FORESTSIDE TOWNHOUSES

SITE INSTRUCTION # 2

Date: April 22nd, 2021

JAP Project No: 19066

Job No : 19066	Sheet No: S-101A
-----------------------	-------------------------

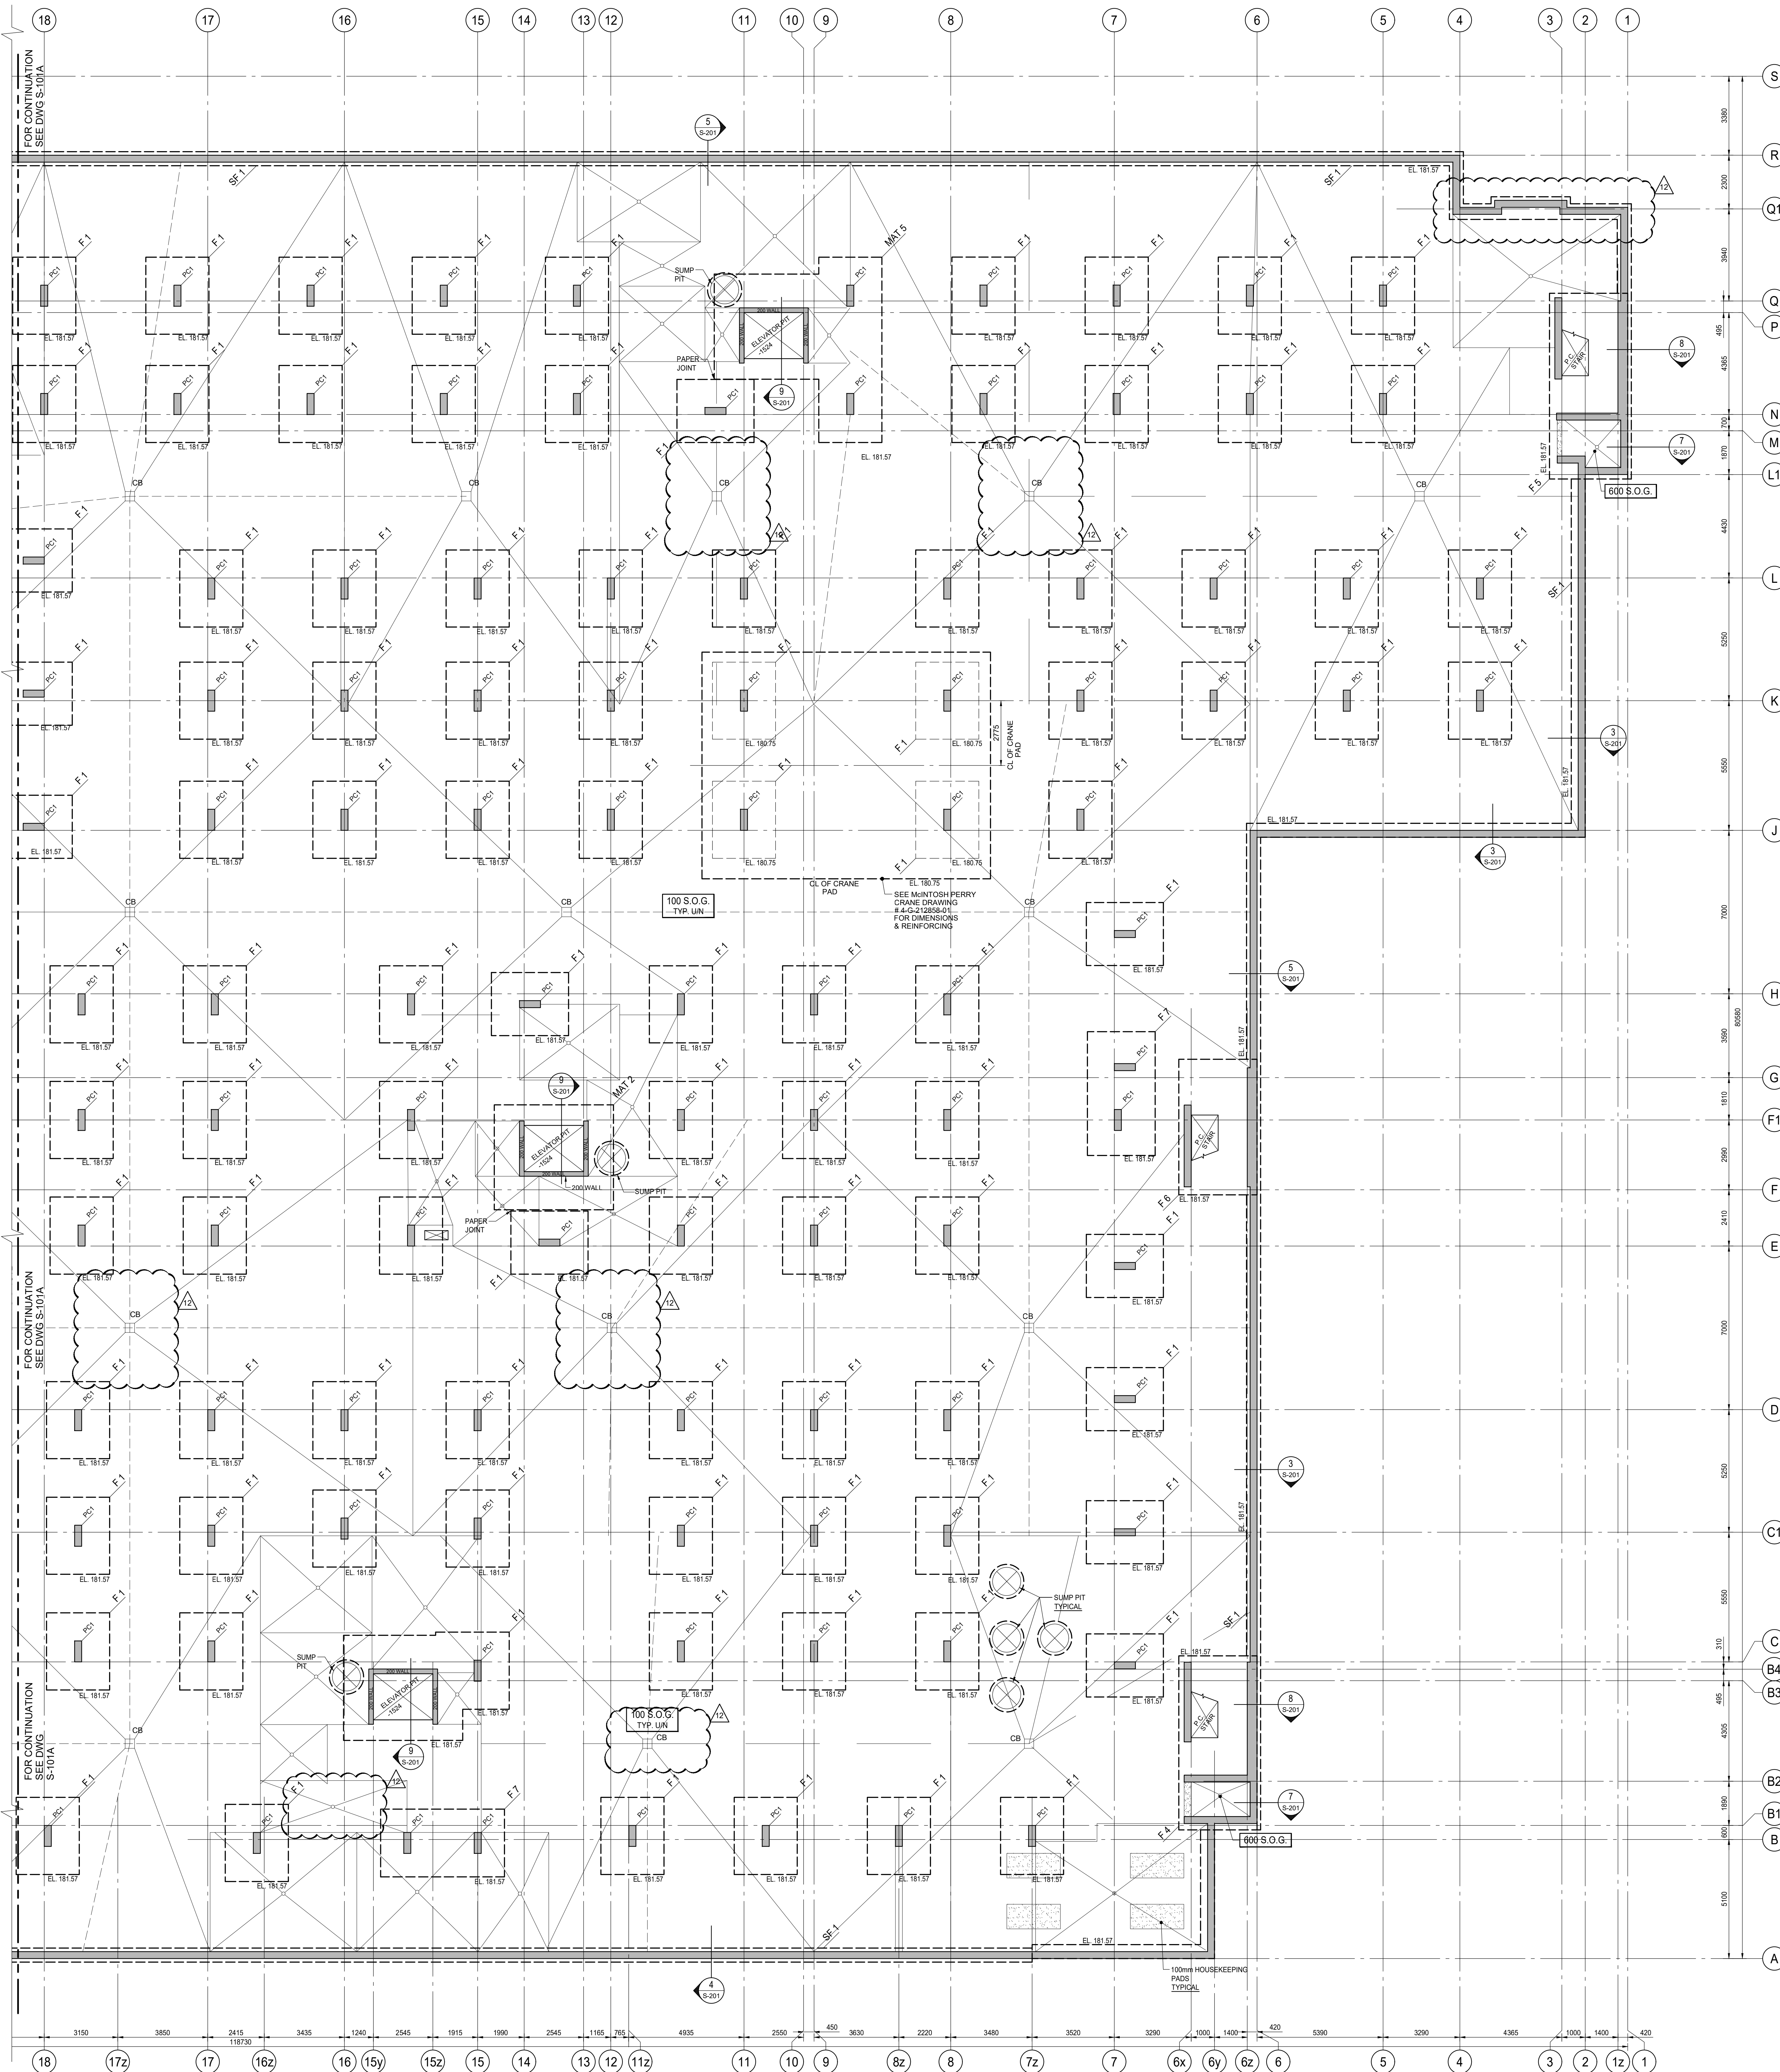
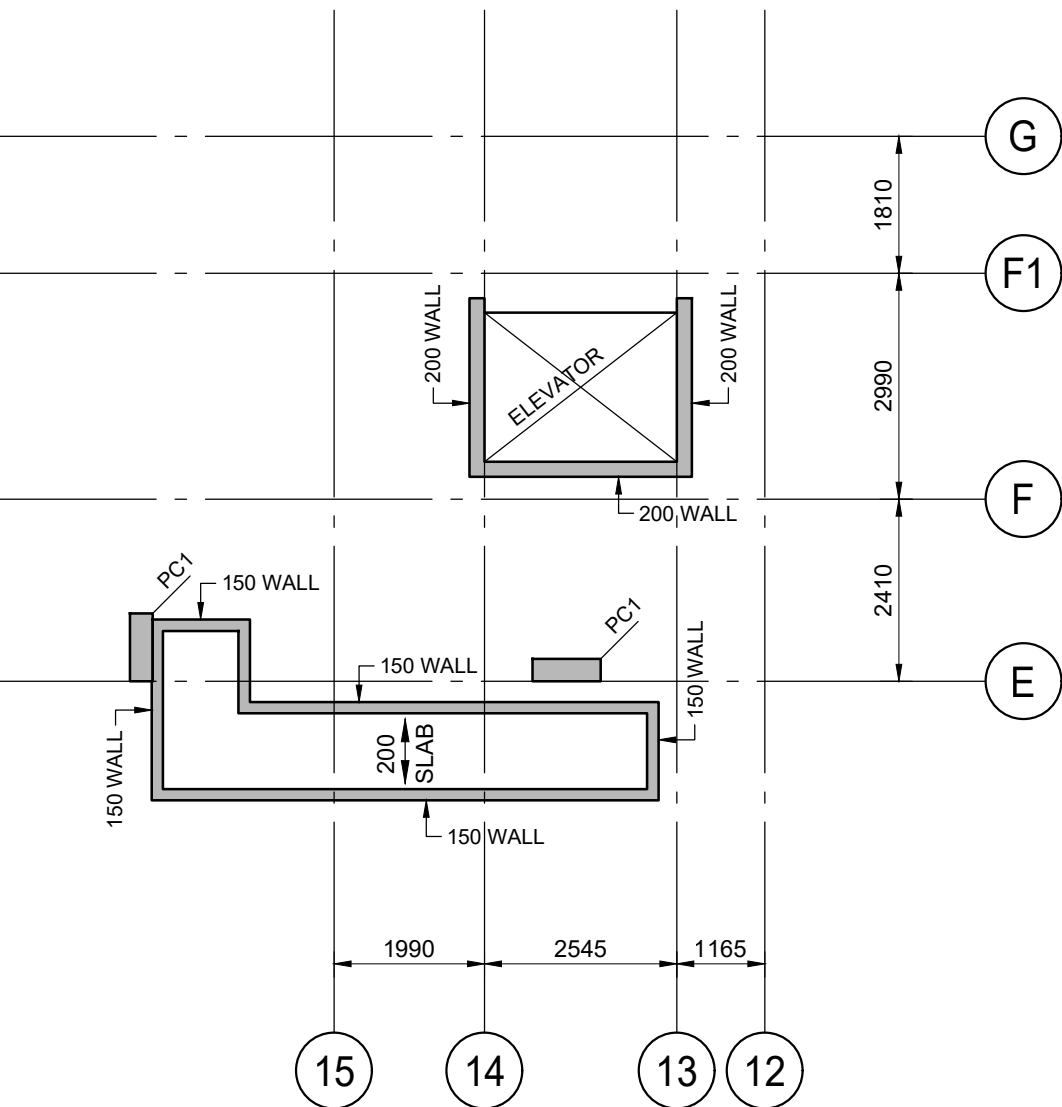
1.1 **Refer to Drawing S-101A & B "P1 UNDERGROUND"**

a) Updated to match latest slab edge

Date Plotted	Date : Apr 22 2021
Drawn By: ND	Scale : 1 : 100
Checked By : JW	Revision Number:
Job No : 19066	Sheet No: S-102A

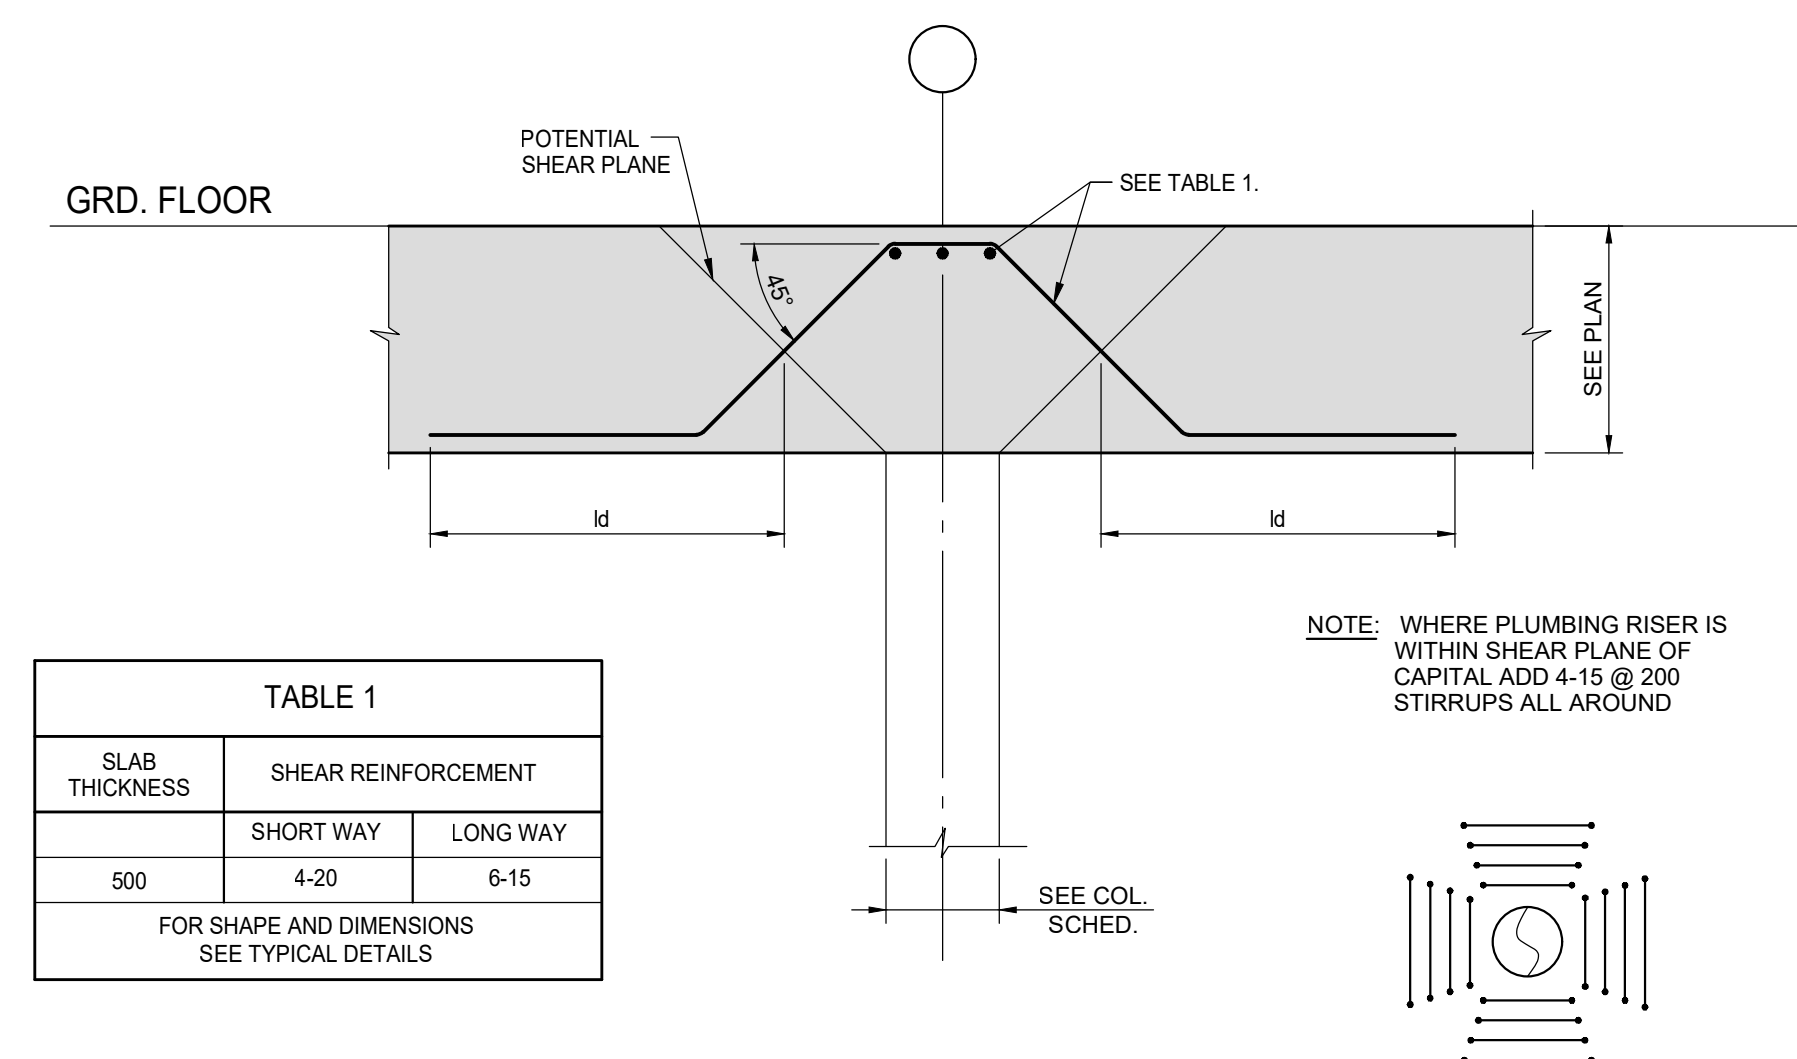
1.2 **Refer to Drawing S-102A & B "GROUND FLOOR FRAMING"**

b) Updated to match latest slab edge
